INDIANA DEPARTMENT OF TRANSPORTATION

FIRST DRAFT MINUTES

October 21, 2010 Standards Committee Meeting

RE: Minutes for the October 21, 2010 Standards Committee Meeting

706-CBRT-01 BRIDGE RAILING TRANSITION WBC OR TBC DETAILS AT END BENT (DRAFT)

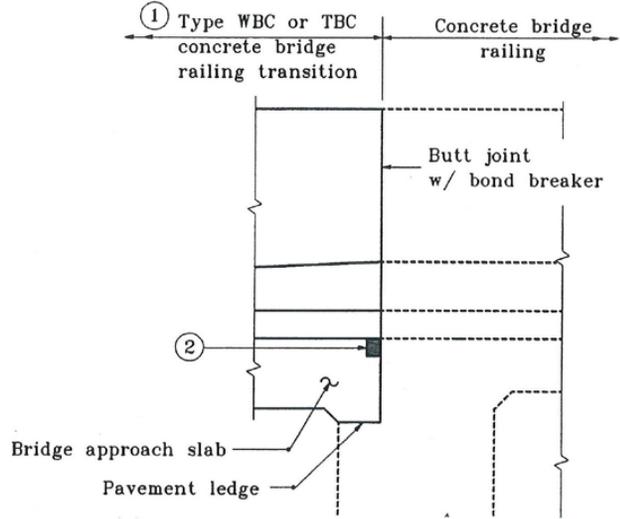
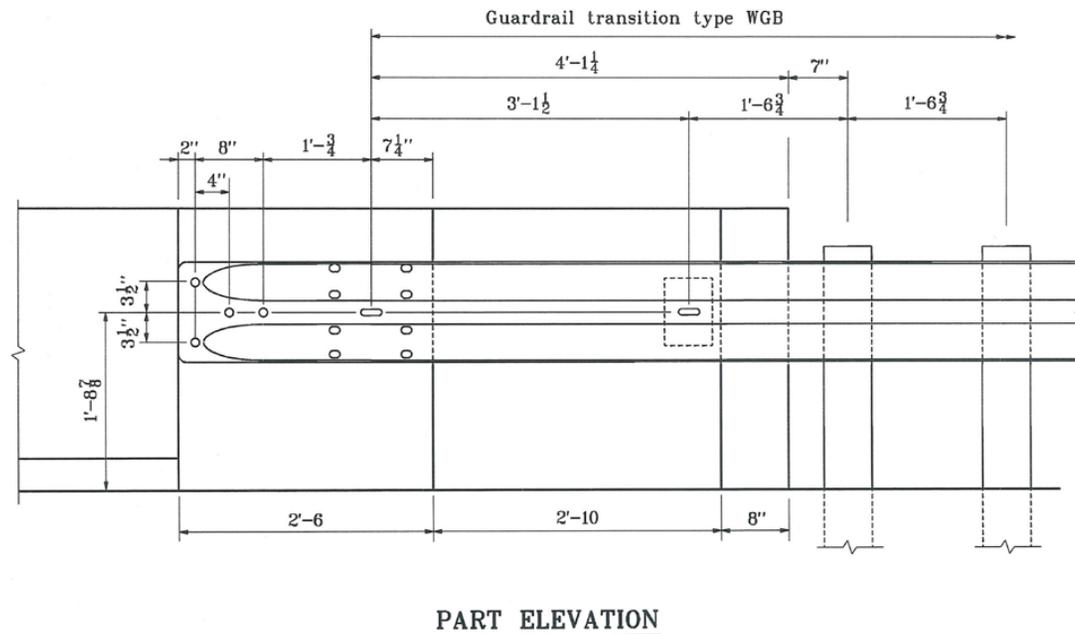
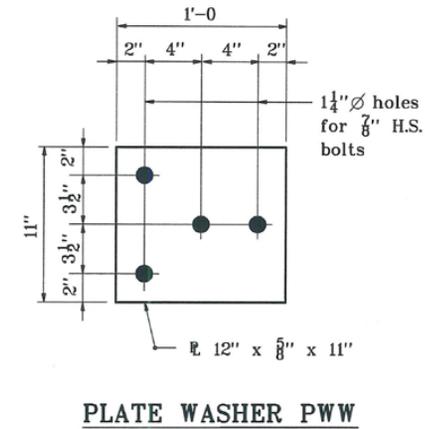
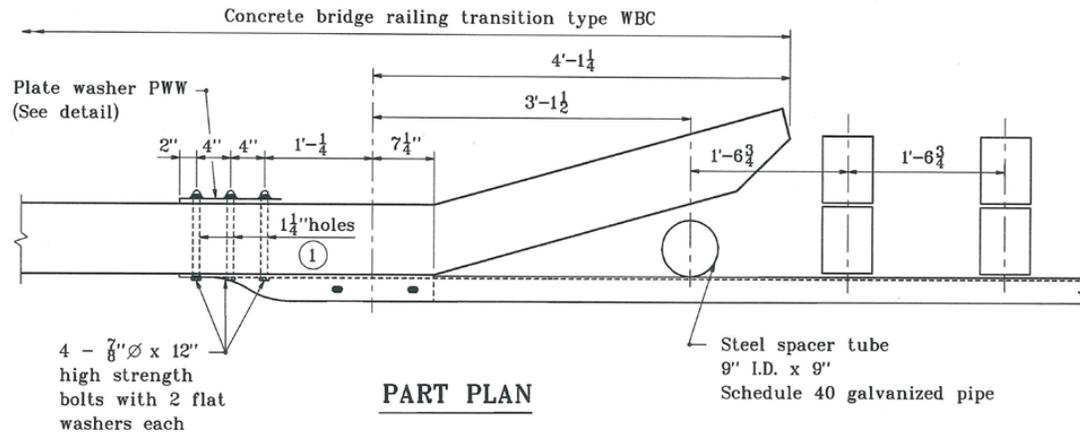
PROBLEM(S) ENCOUNTERED: There are no standard details for the section of concrete bridge-railling transition above the mudwall for the TBT, or truck-height, transition. The existing such standard details for the WBC or WBT, or common-height transitions, show a reinforcement pattern which does not match that in the main portion of the transition.

PROPOSED SOLUTION: Develop standard details for the mudwall portion of the TBT transition, and modify the existing details for the WBC and TBC transitions, so that the reinforcement pattern in the mudwall portion matches that in the main portion.

Introduced and presented by Mr. Uremovich.
 Need to make the diagram show the bar as vertical, not horizontal. (586)

A couple of revisions to be made to clarify details. This will be accomplished by Mr. Uremovich.

706-CBRT-0302 BRIDGE RAILING TRANSITION WBC ATTACHMENT OF GUARDRAIL

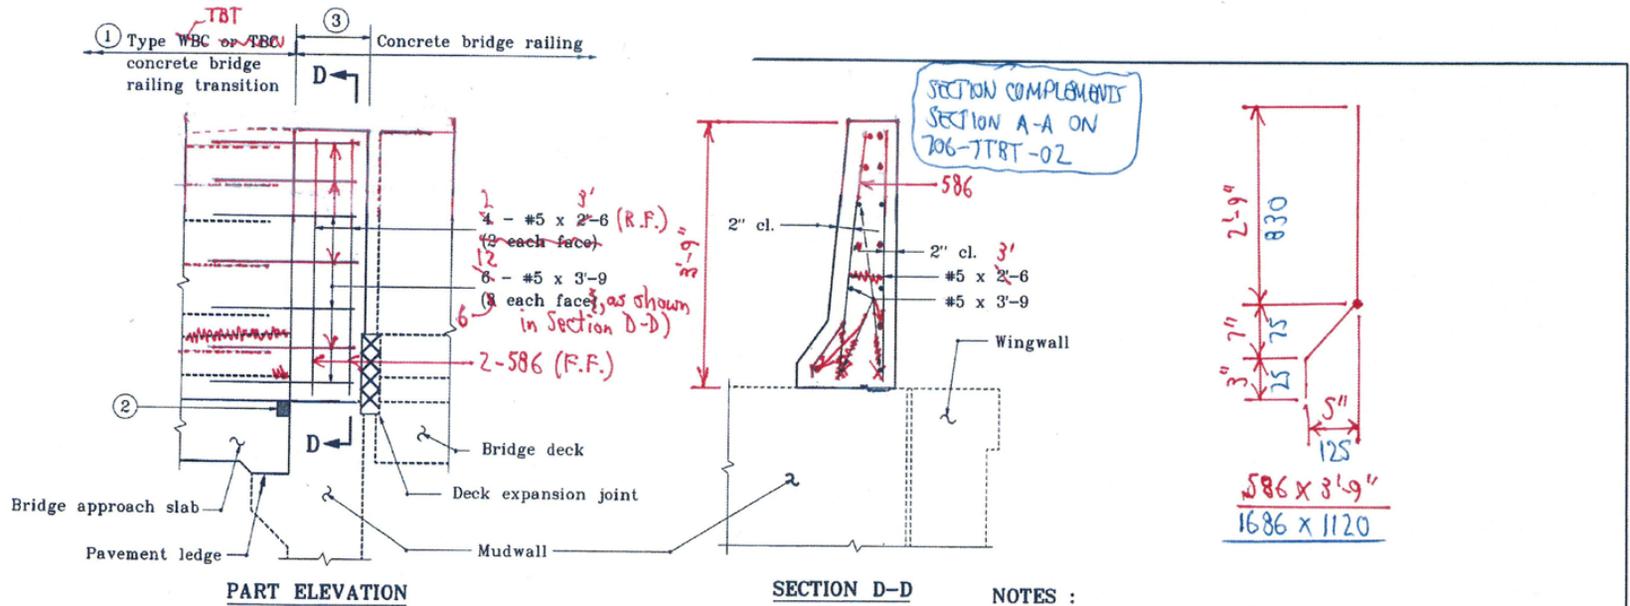
APPLICABLE STANDARD DRAWINGS: Revise 706-CBRT-01 for WBC and TBC transitions; add new 706-CBRT-03 for TBT transition; change existing 706-CBRT-02 to -04 and 706-CBRT-03 to -02 for drawings-series-order logic.
